U. S. NUCLEAR REGULATORY COMMISSION

Report No: 50-331/99014(DRP)

Facility: Duane Arnold Energy Center

Dates: November 11 through December 21, 1999

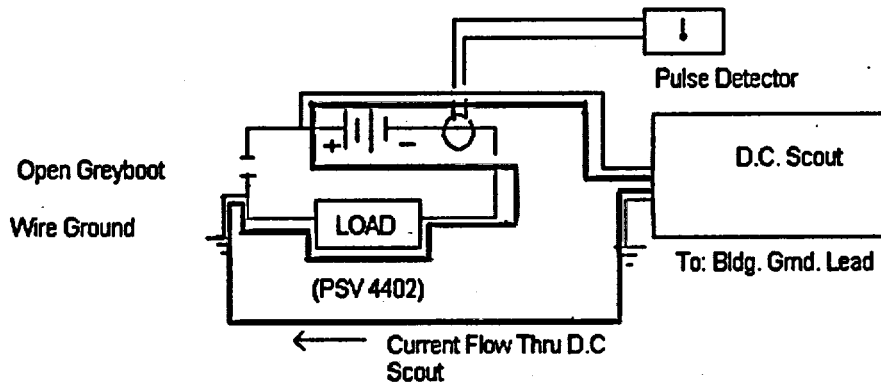
Electrical maintenance technicians were troubleshooting a ground on the 125 VDC Division I electrical system at the time of the relief valve lifting. The system's in-line ground detection system indicated a ground on the negative portion of the circuit. Electrical maintenance technicians were using a "non-intrusive" ground detection device (DC Scout) to locate the source of the ground. The ground detection device had narrowed down the ground to a DC power sub-panel. As directed by the vendor manual, electrical maintenance technicians had tied the DC Scout input lead into the positive side of the 125 VDC system. The DC Scout output lead was tied into the building ground. When amperage allowed through the DC Scout was increased to 50 milliamperes, the pilot solenoid valve for relief valve PSV 4402 actuated. The reason the pilot valve actuated was because there was also an open environmentally qualified wire splice, known as a greyboot connection, at the pilot valve in addition to the ground. The greyboot connection was open on the positive side of the pilot solenoid. This masked the fact that the ground was also on the positive side of the pilot valve circuitry. This resulted in the electrical maintenance technicians erroneously connecting the DC Scout ground detection device to the positive bus.

The simplified diagram above shows the 125 volt system with the actual system faults and the DC Scout ground detection device as it was installed. The heavy line represents the current and flow-path which caused actuation of the pilot solenoid valve. The inspector's review of the vendor manual found that the electrical maintenance technicians connected the DC Scout in what would be considered the proper manner to troubleshoot the ground as indicated by the 125 VDC system's ground detection system.
